**TSG-RAN Meeting #14
Kyoto, Japan, 11 - 14, December, 2001**

TSGRP#14(01) 0860

Title: Agreed CRs to TS 25.427

Source: TSG-RAN WG3

Figure 17: Structure of the payload for OUTER LOOP PC control frame

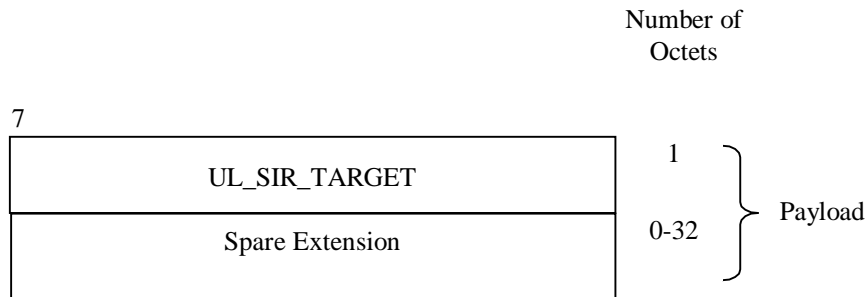
- T2 description now refers to the DL NODE SYNCHRONISATION control frame.
	- UL OUTER LOOP POWER CONTROL control frame has been renamed to OUTER LOOP POWER CONTROL control frame.
	Impact Analysis: Impact assessment towards the previous version of the specification (same release): This CR has [isolated impact] with the previous version of the specification (same release) because previous implementations may have not been clear to which frames T1, T2 and T3 apply. This CR has an impact under [functional] point of view. The impact [can] be considered isolated because the change affects [one] [system function].
Consequences if not approved:	⌘ The current text procedural text may lead to incorrect implementation. Such inconsistencies in the specification can lead to multi-vendor interoperability problems.

Figure 18: Structure of the payload for the DL NODE SYNCHRONISATION control frame

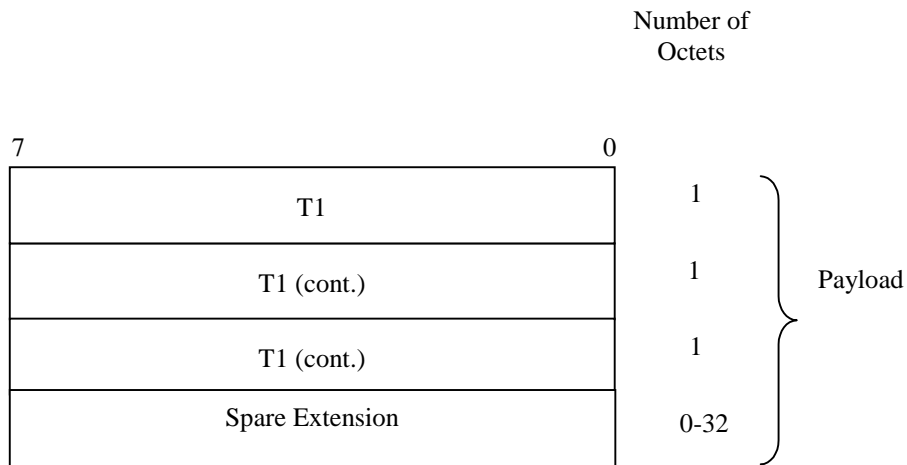
Figure 18 shows the structure of the payload for the DL NODE ~~Synchronisation~~ SYNCHRONISATION control frame.

Figure 19: Structure of the payload for UL NODE SYNCHRONISATION control frame

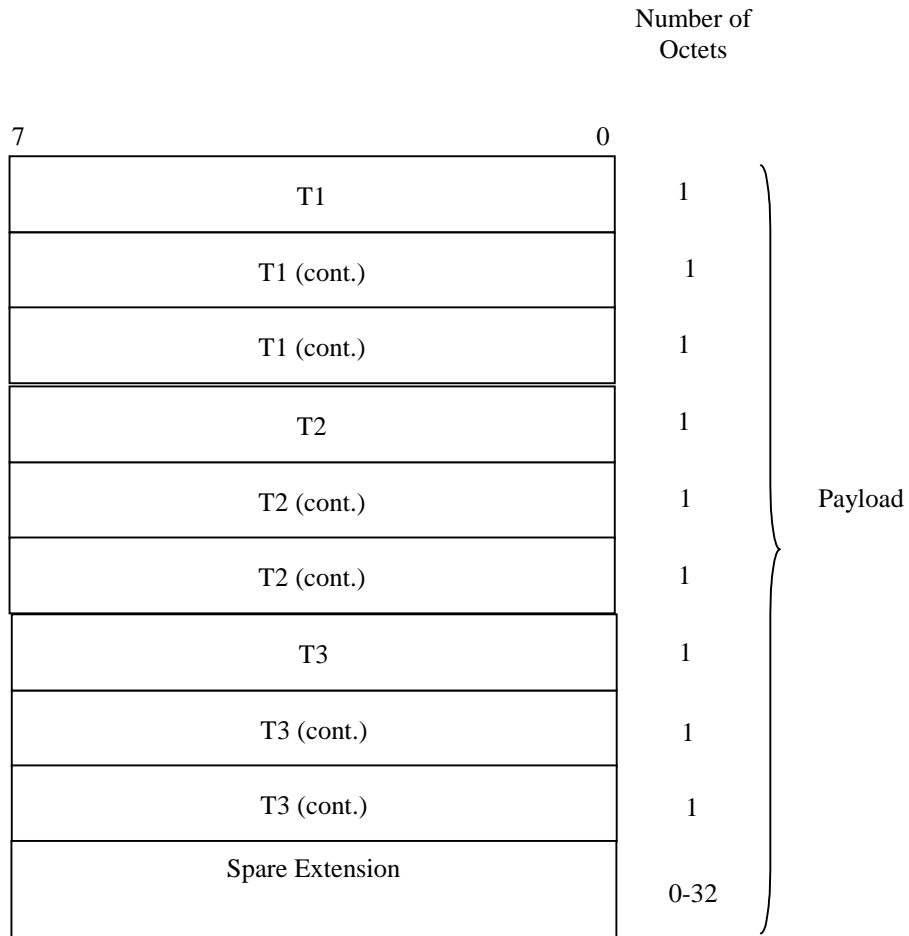
The payload of the UL ~~Node-synch~~[NODE SYNCHRONISATION](#) control frames is shown in figure 19.

Figure 16: Structure of the UL SYNCHRONISATION control frame

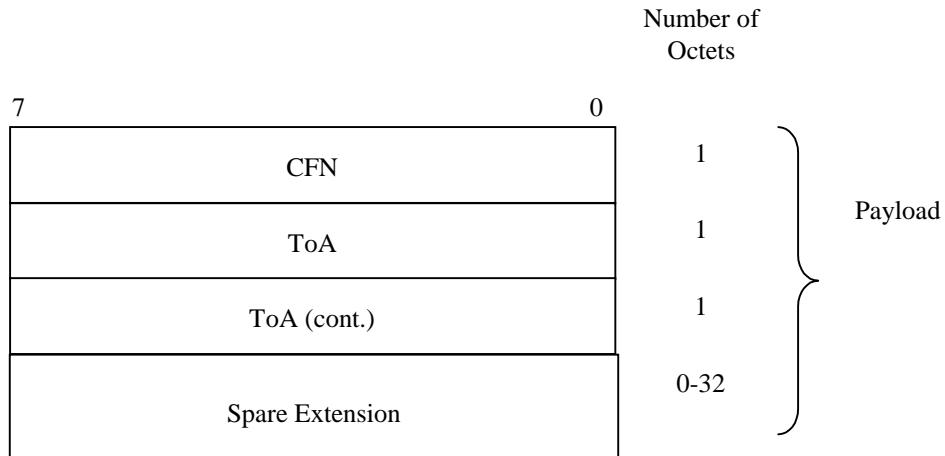
Figure 16 shows the structure of the payload when the control frame is used for the user plane synchronisation ~~(UL)~~.

Figure 16: Structure of the UL SYNCHRONISATION control frame

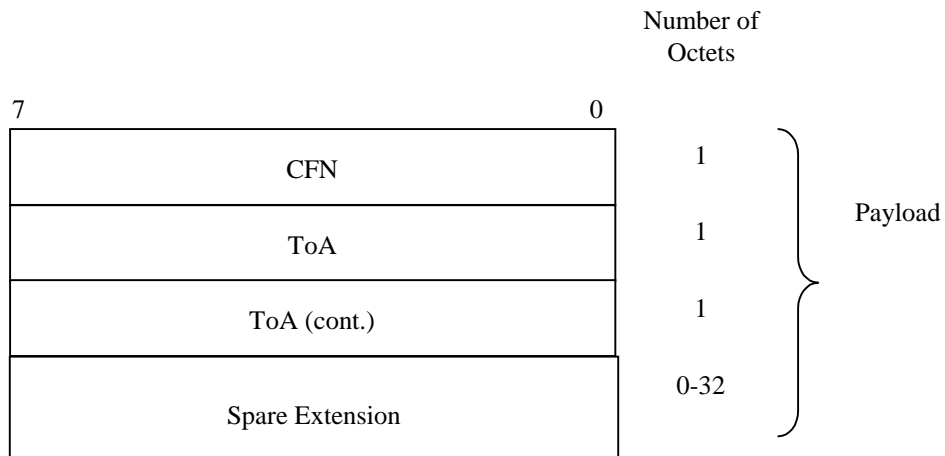
Figure 16 shows the structure of the payload when the control frame is used for the user plane synchronisation ~~(UL)~~.
